Independent Verification Memo - WO-01 Pump Module Selection (Agent B)

Editable verification diagram: energy per acceptance run by candidate with gaps to P2, plus the two corrections to A's brief. Bars use the trusted table only.

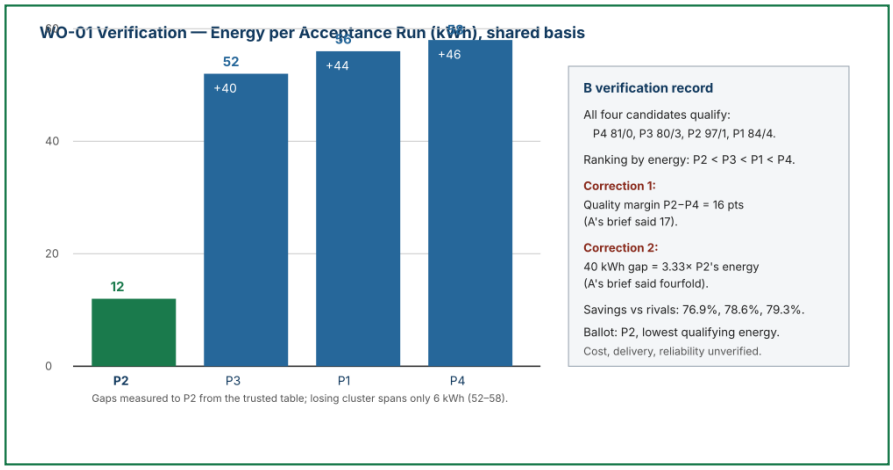
Measured per-run energy: P2 12, P3 52, P1 56, P4 58 kWh. Gaps to P2: +40, +44 and +46 kWh, identical to A's arithmetic. The losing cluster spans only 6 kWh (52 to 58), so no plausible retest shift within that cluster can close a 40 kWh gap; the ranking is robust. Savings versus rivals are (52-12)/52 = 76.9%, (56-12)/56 = 78.6% and (58-12)/58 = 79.3%, so A's 'roughly 77 to 79 percent' is fair. One correction: A calls the 40 kWh gap more than a fourfold multiple of P2's energy, but 40/12 = 3.33x, so about three and a third times is exact. The conclusion stands either way.

A's brief separates measured facts from unverified fields correctly and lists the right open questions: repeatability of the 12 kWh figure, the meaning of P4's zero-defect record, possible unit-cost offsets over a service life, and delivery timing. None of these is a finding today, and none changes the ranking. The trusted table is reproduced unchanged. I confirmed the watchlist note that P4 pairs zero raw defects with the highest measured energy, an odd combination that merits a retest request. Beyond the two numeric slips noted above, I found no misstatement of the supplied facts, no invented measurements and no unsupported claims in A's prose.

P2: quality 97, one raw defect, 12 kWh per run on the shared acceptance basis. All four candidates qualify; P2 has the lowest energy by 40 kWh over P3, 44 over P1 and 46 over P4, a margin larger than the whole 6 kWh spread of the losing cluster. Two wording slips in A (16-point margin; 3.3x, not fourfold) do not alter the result.
